# Lower Thames Crossing

## 9.190 Post-event submissions, including written submission of oral comments, for ISH13

Planning Inspectorate Scheme Ref: TR010032  
Examination Document Ref: TR010032/EXAM/9.190

### Plate A.1 Existing Orsett Cock junction route and lane name convention diagram

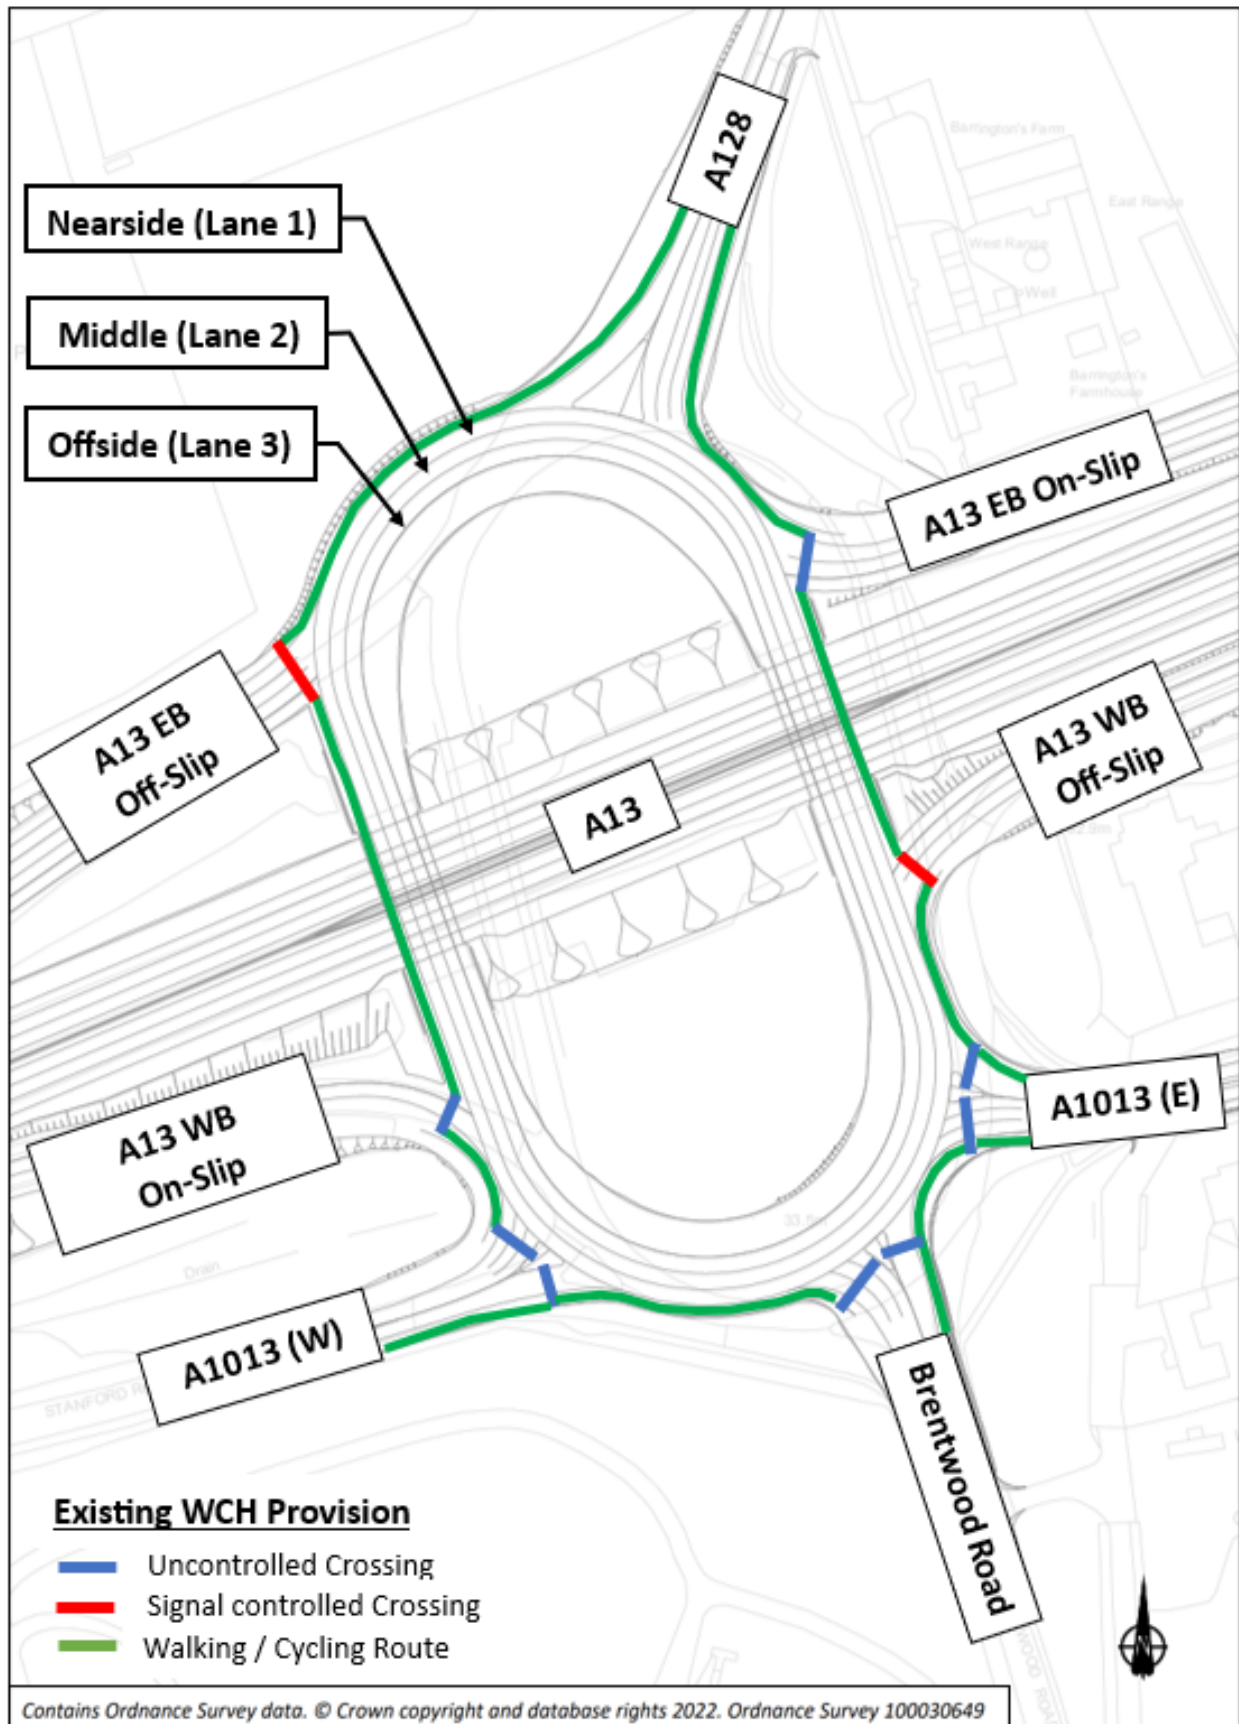
- A.3.2 To support the submissions associated with the Orsett Cock junction, Plates Plate A.1 and Plate A.2 have been prepared to show the following features of the junction for the Existing and Proposed layouts respectively:

- A.3.4 For simplicity, lane markings and traffic signals are not shown in Plates Plate A.1 or Plate A.2.

Drawing Title: ALTERNATIVE A13 MERGE AT ORSETT SHEET 1 OF 2

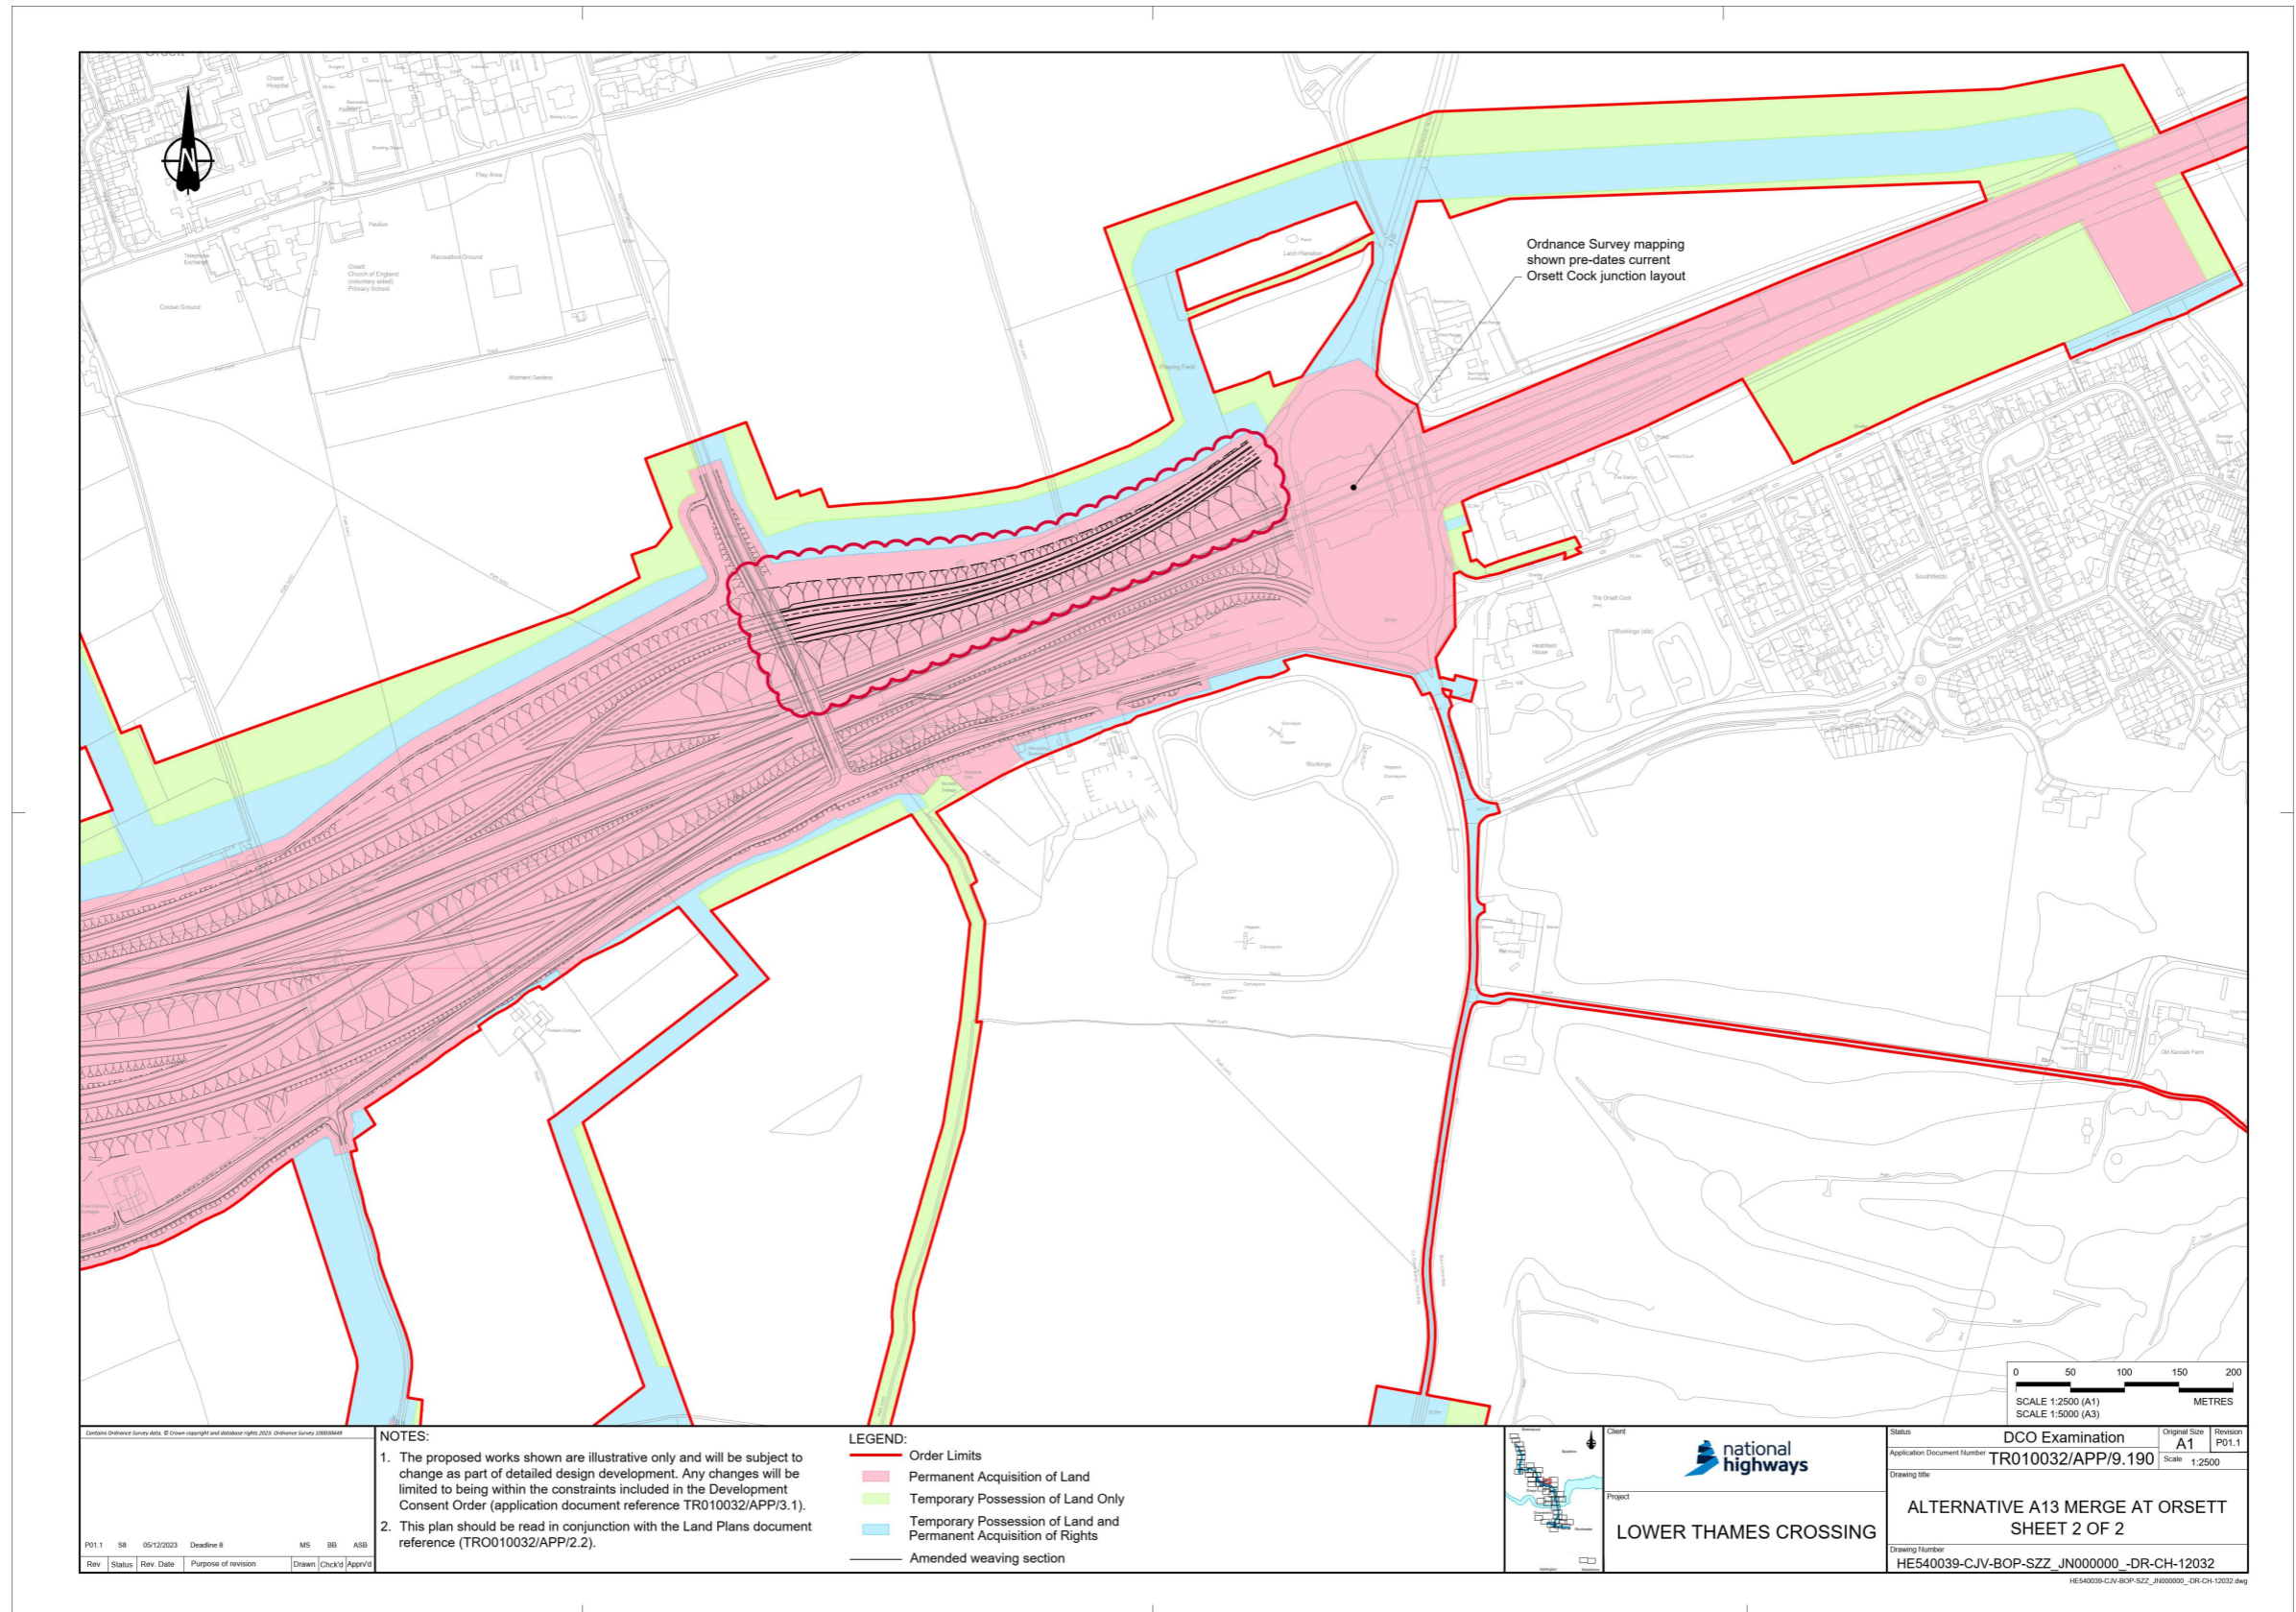
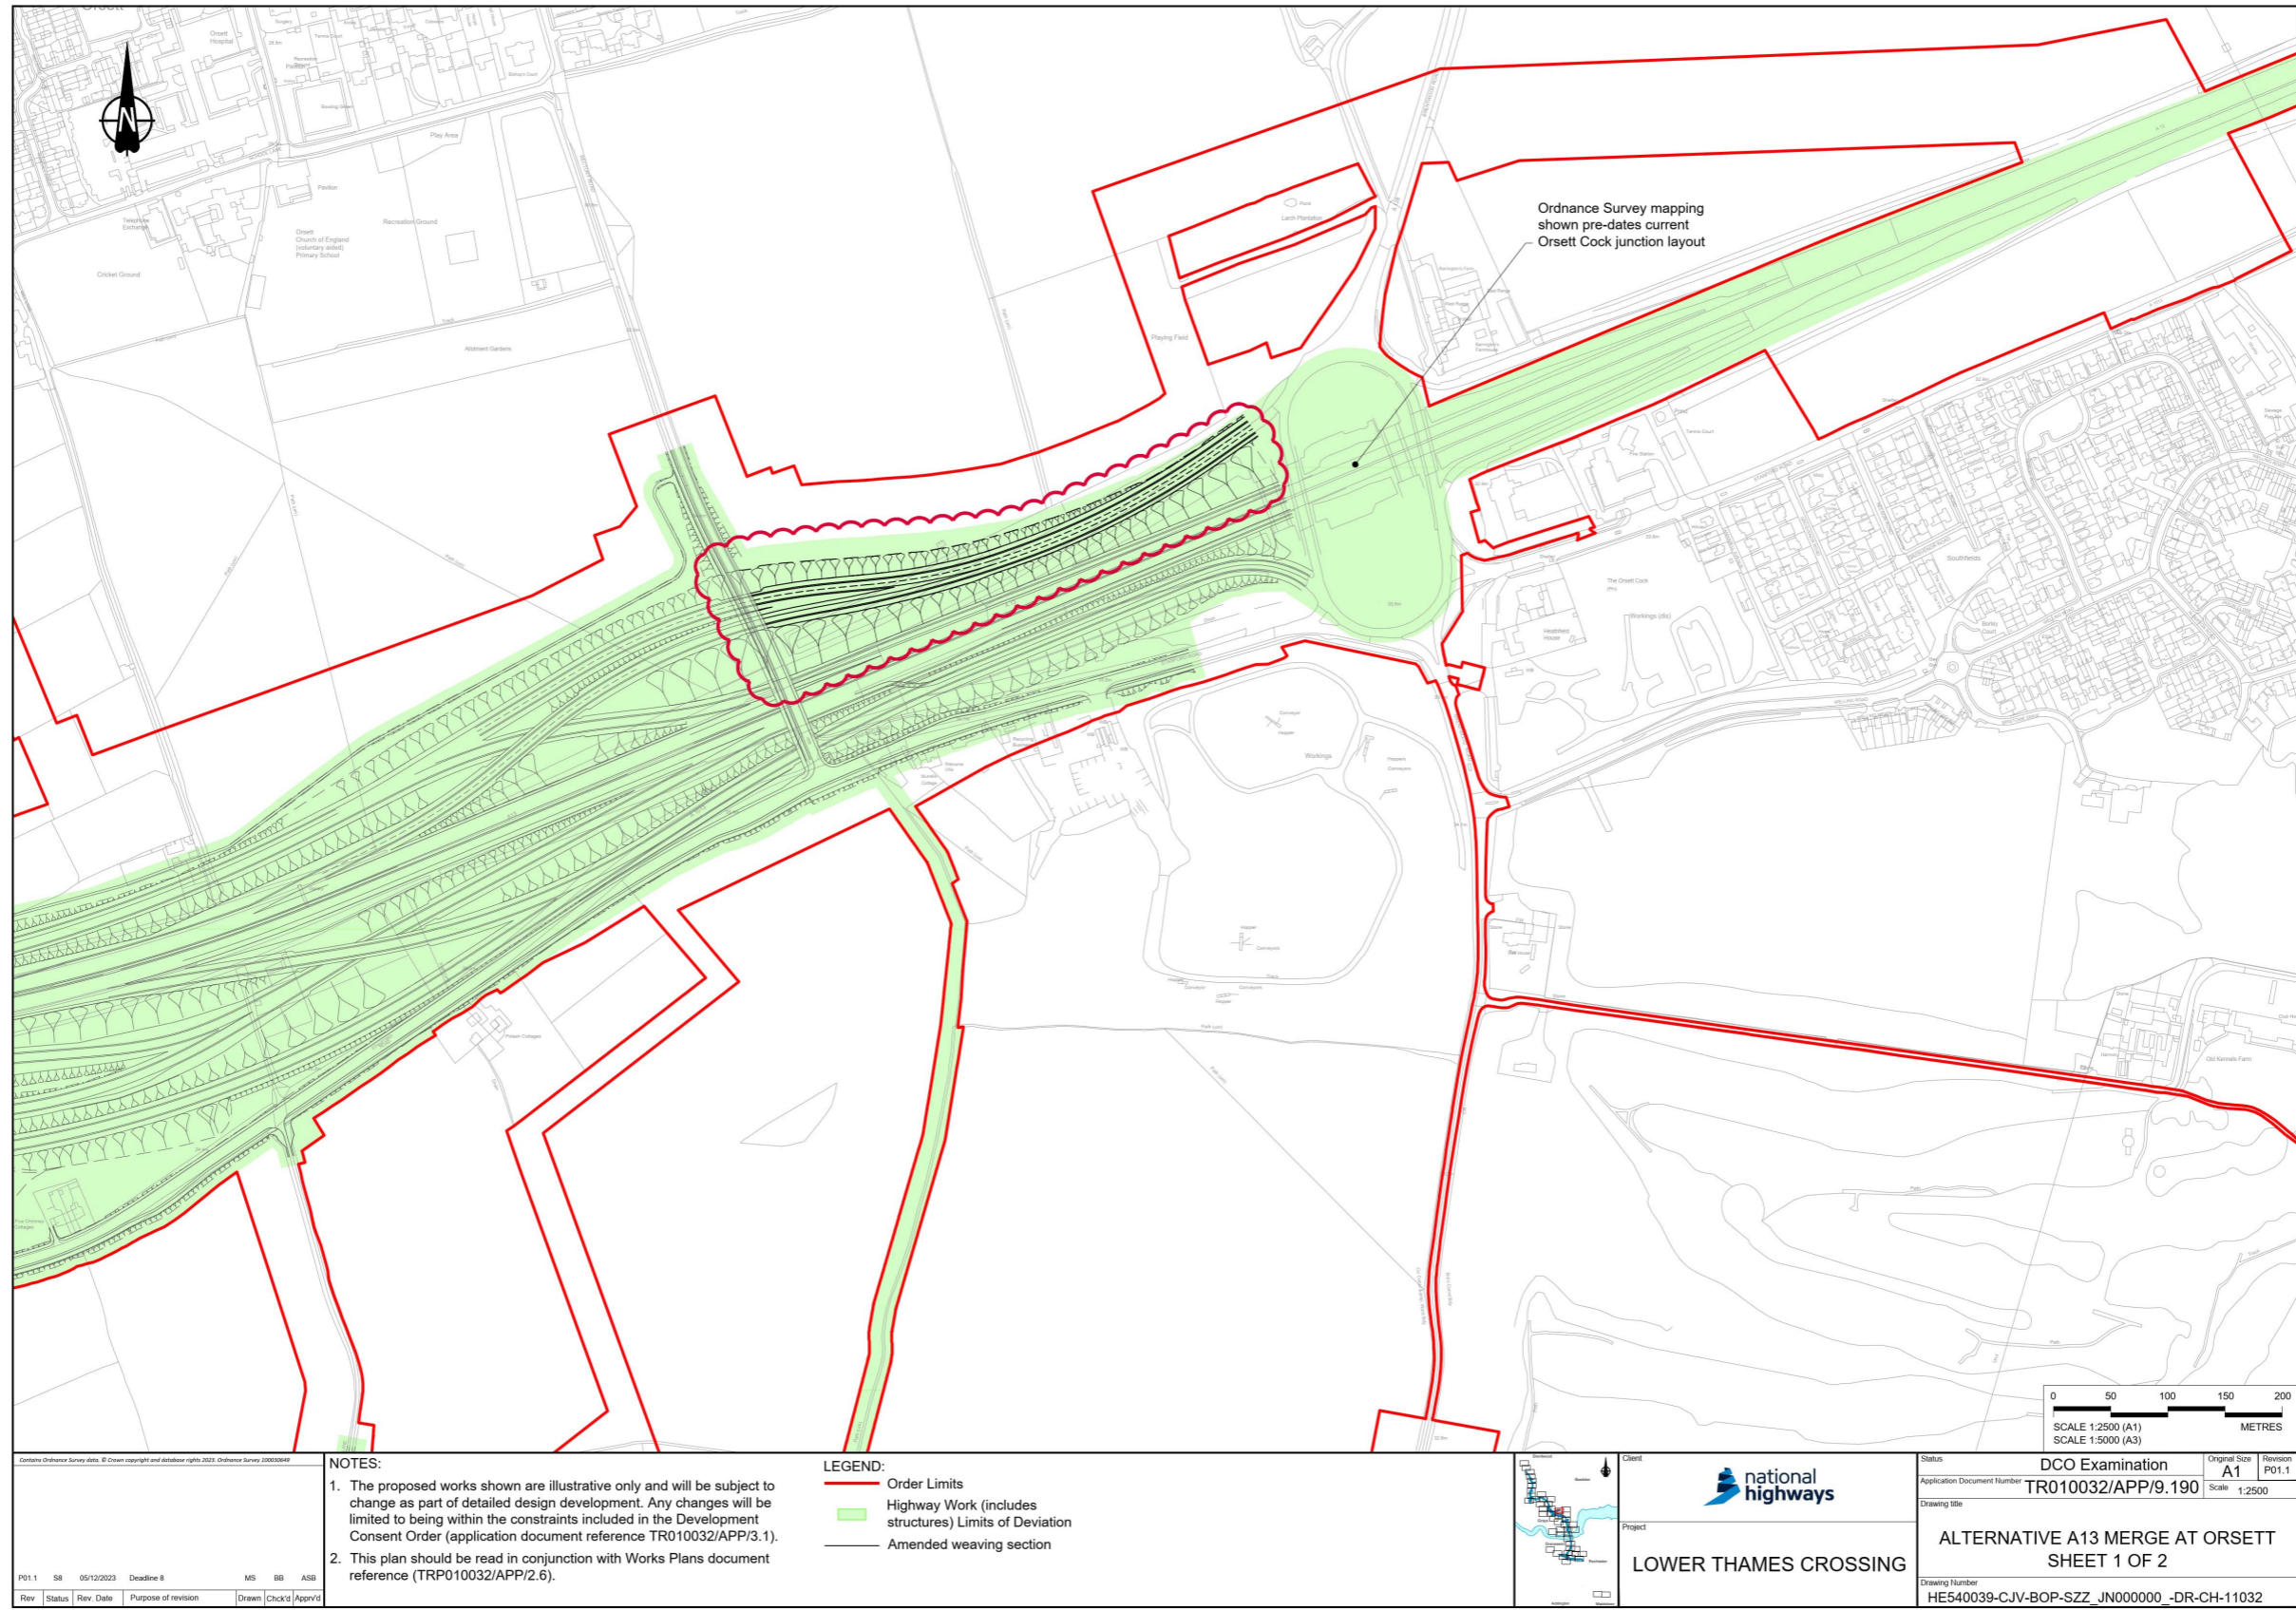
A.2.1 Hearing Action Point 1 requests '*Please submit a drawing demonstrating the proposition that relevant additional weave length can be provided without a requirement for additional land and within the limits of deviation. Please provide an amendment to the General Arrangement Plans Vol C [REP7-028/029] to show this change. Thurrock Council may comment at D9.*'

A.2.2 In response to this Action Point, the Applicant has prepared two drawings (which can be found at Appendix A.1 to this Annex) showing the amended weaving section on the approach to Orsett Cock roundabout presented as follows:

A.2.3 As demonstrated in the above-referenced drawings, the Applicant confirms that this amendment can be accommodated within the flexibility of the DCO and therefore the Applicant does not consider it necessary to update the General Arrangement Plans. The Applicant would note that Requirement 18 secures measures at the detailed design stage which would minimise the traffic delays arising from the operation of the Project, and also optimises the performance of the roundabout.
